Photon Energy Australia Pty Ltd | Level 2 / 55 Grafton Street | Bondi Junction NSW 2022 | Australia

**Re: Gunnedah Solar Farm – Question form the Commission**

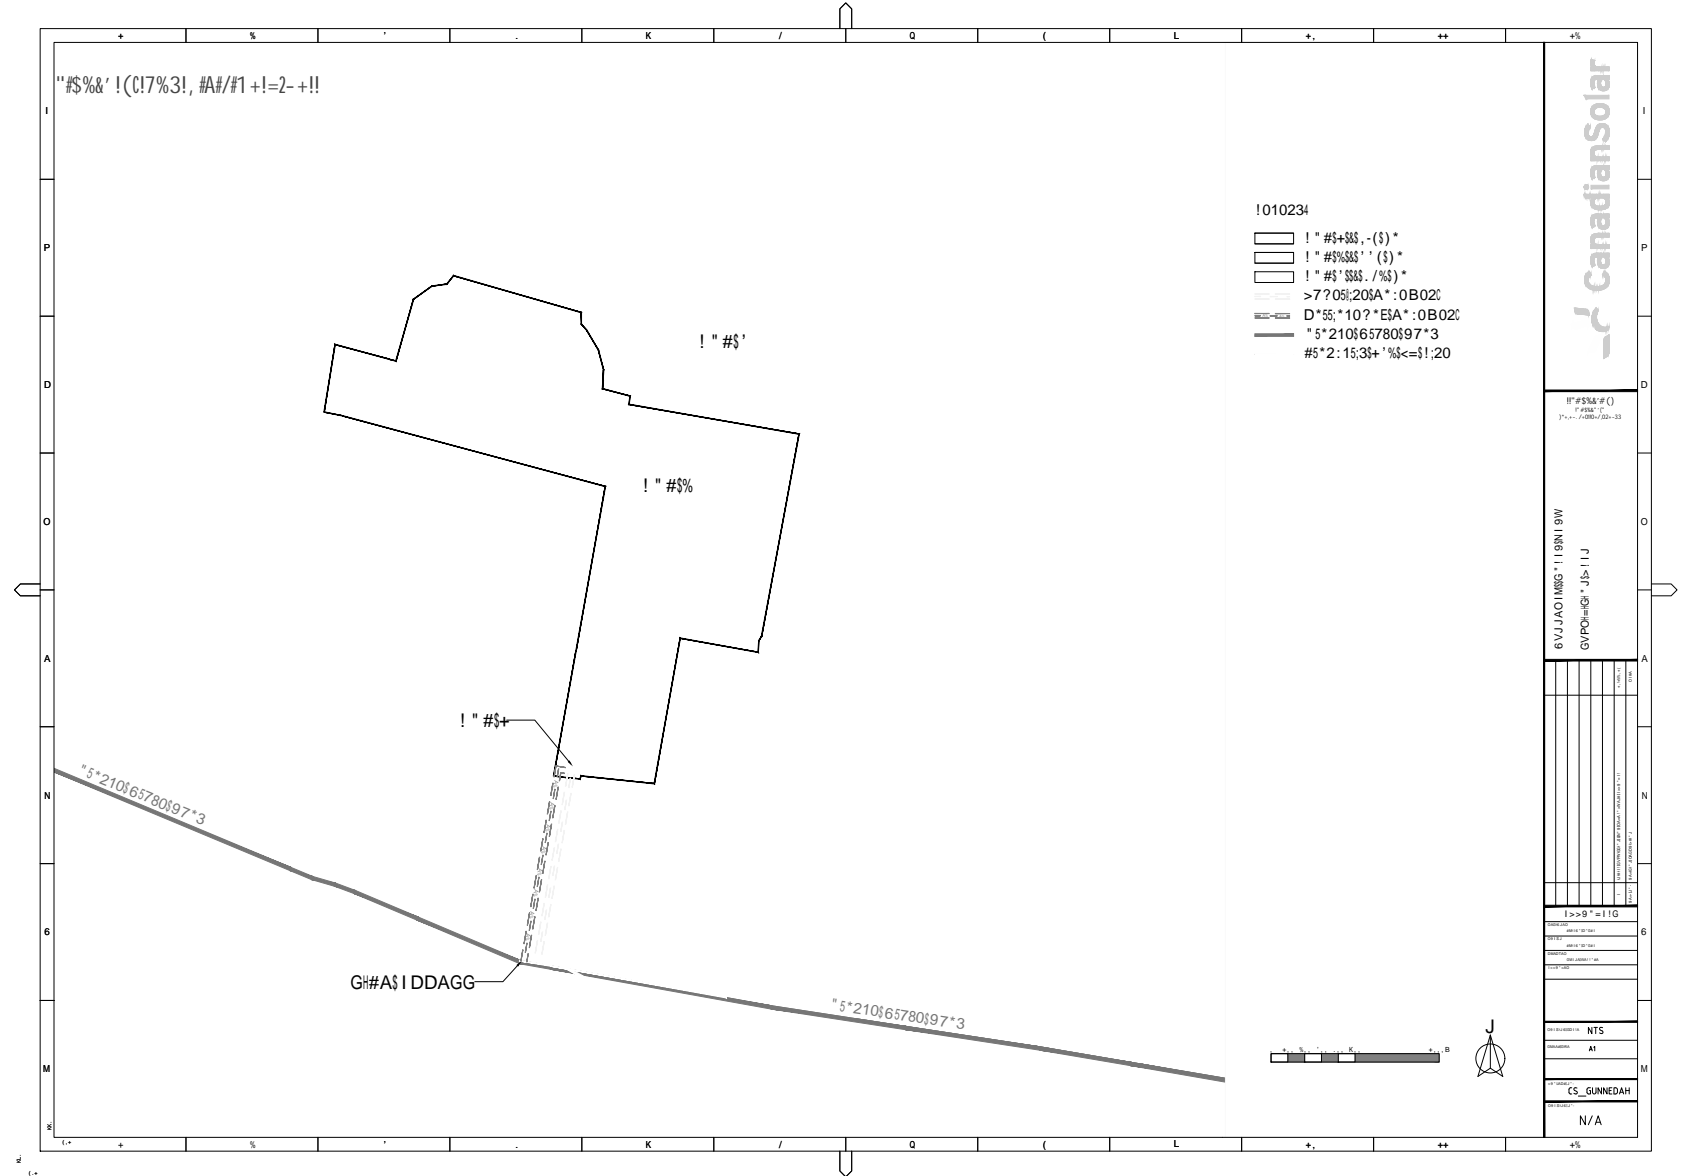
**3. Provide a cross-section figure showing the location of VP9 and the solar farm. The cross section should include Reduced Levels (RLs).**

Please refer to Figure 2 and Figure 3. Figure 2 shows the actual ground levels based on the information in the flood management plans and Figure 3 is using a Figure 3 vertical exaggeration of 1:10.
